Subject: Corvette Coupe Body Rework for Larger Racing Tires (Rear Wheels)

Model and Year: 1963 - 1964 Corvette

Source: Chevrolet Service News

Date: August 1964, Volume 36, Issue Number 7

Fig. 2—Rework of 1963-64 Corvette Model 837 for Installation of Larger Tires

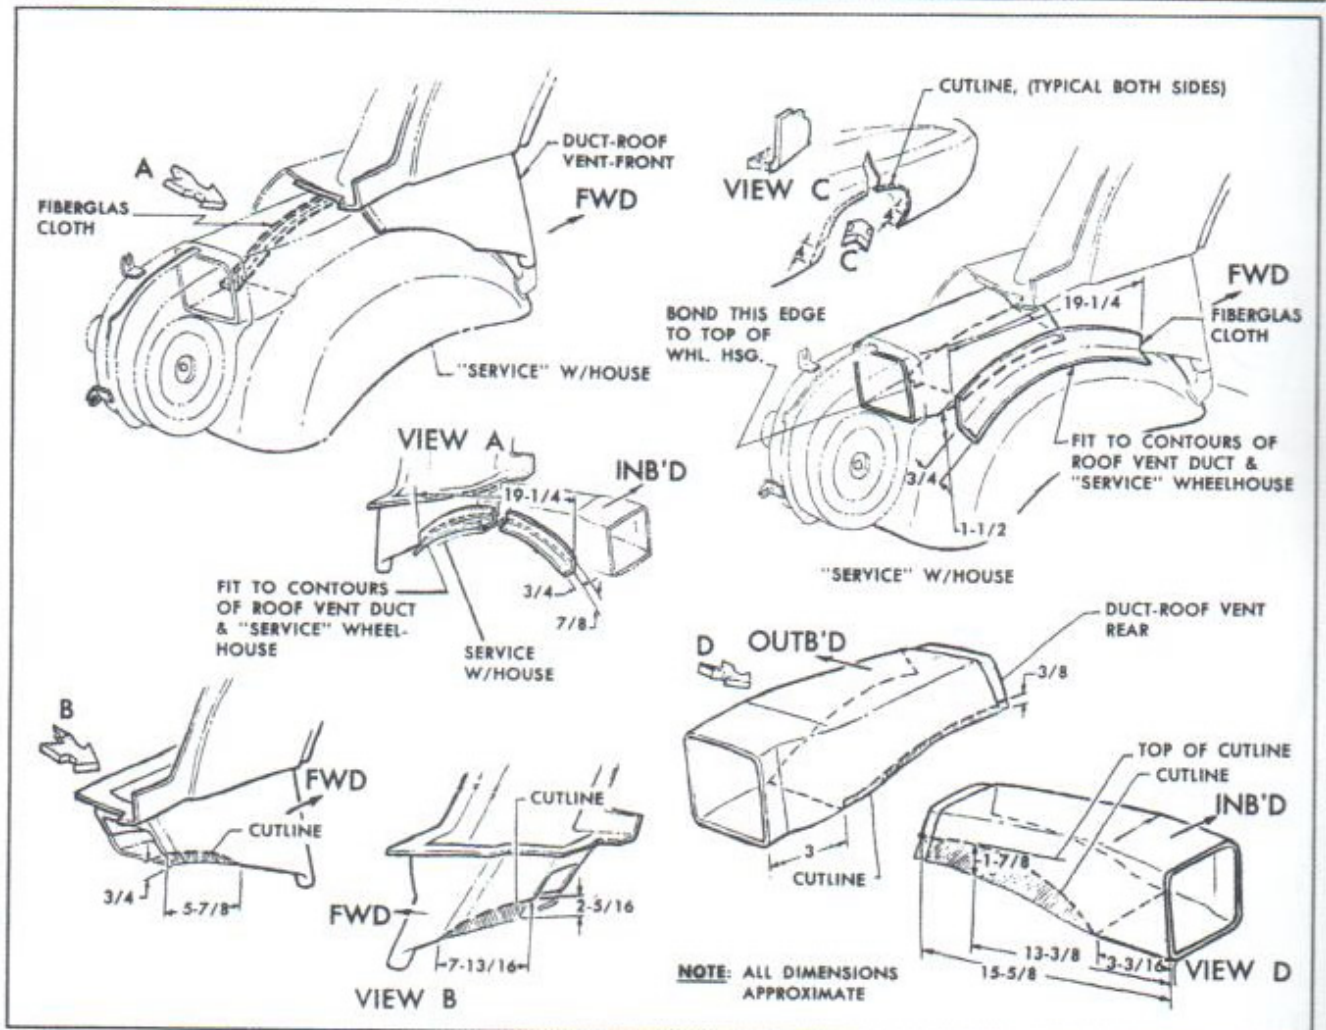
Refer to Figure 2 for details of the installation of the larger wheel housings, the provision of extra clearance between the tire and wheel openings, and the

modification of the body rear compartment air exhaust duct. In those areas where cutting and rebonding of fiberglass is involved, regular shop practices and materials should be used. The use of the materials show in Group 12,800 of the Chevrolet Parts Catalog is suggested.
